*Comments of the **Natural Resources Defense Council** on  
Emissions Performance Standard Update Documents*

The Natural Resources Defense Council thanks the Washington Department of Commerce (hereafter “Commerce”) for the opportunity to comment on documents pertaining to the Emissions Performance Standard (EPS) Update.

### Comparison with existing unit emission rates

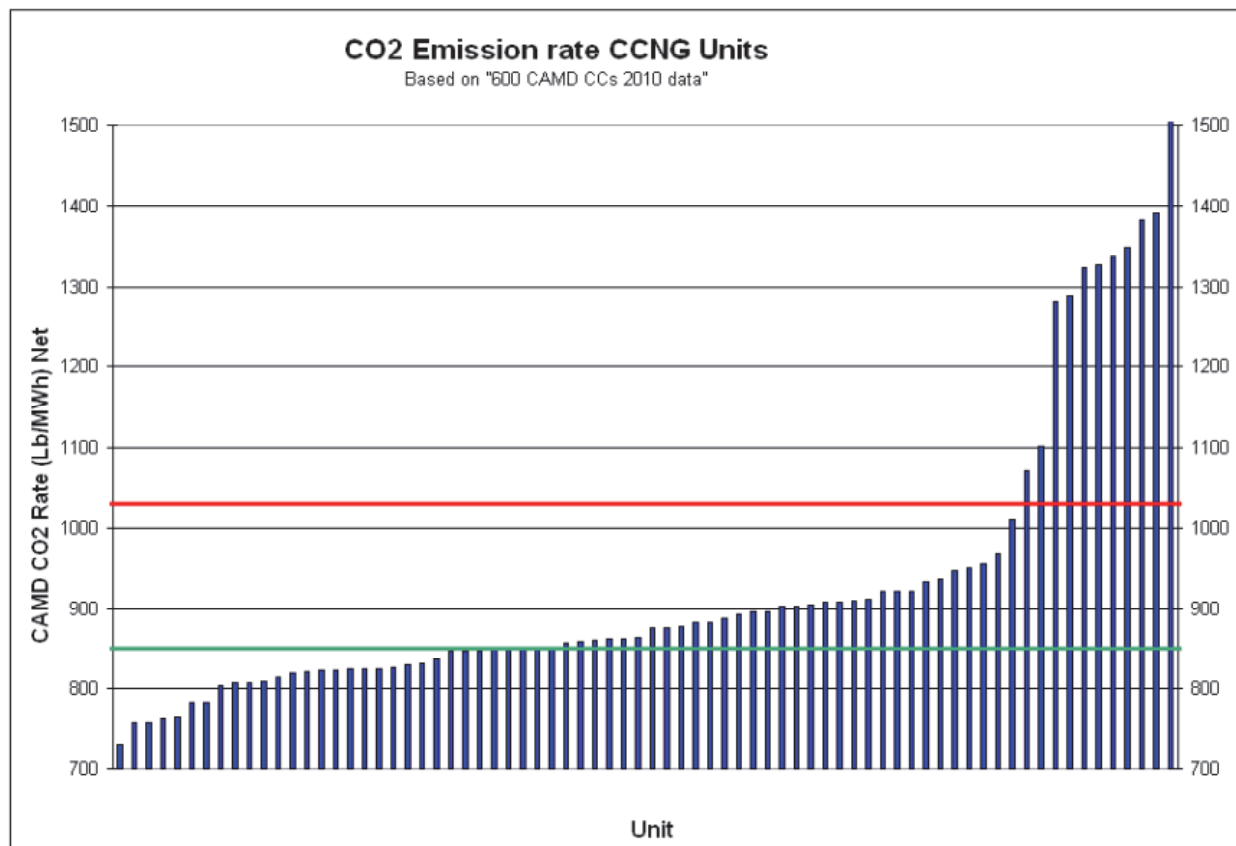
The figure above shows the emission rates from the units in EPA's data set, the EPA's EGU NSPS proposed limit of 1,000lb CO<sub>2</sub>/MWh and a possible alternative of 825-850 lbs/MWh, all expressed as net emissions. Note that approximately one-half of the existing units have already met the recommended alternative limit. It should be noted that these units have experienced in-use variation in temperature, altitude and performance degradation with time, and so incorporate the factors that Commerce assigns to manufacturers' performance specifications.
